Addendum Cover Page

2. Addendum to (Title): Multiscale Thermohydrologic Model			
3. DI (including Revision and Addendum No.): ANL-EBS-MD-000049 REV 03 AD 01			
	Printed Name	Signature	Date

11. Revision and Addendum No.	12. Description of Change		
REV 03 AD 01	This addendum addresses the following CRs: 6521, 6543, 6730, 7191, 7892, 7969, 9740, 10733 and 10846.

Figure 6.3-77[a]. CCDF for (a) Peak Drift Wall Temperature and (b) Peak Waste Package Temperature for the Range of Parametric Uncertainty Addressed by the MSTHM

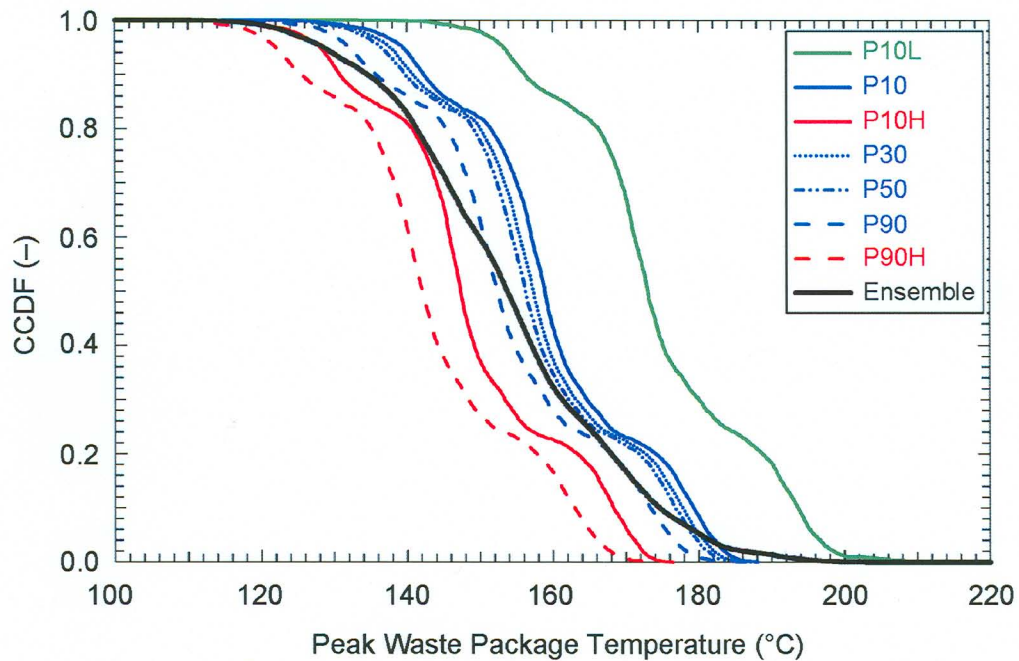
10. Remarks For clarity, Figures 6.3-77(a), 6.3-78(a), and 6.3-79(a) were replaced without alteration to the data; the plot curves now correspond to the legends. See also the editorial change on p. 6-47(a).			
Change History
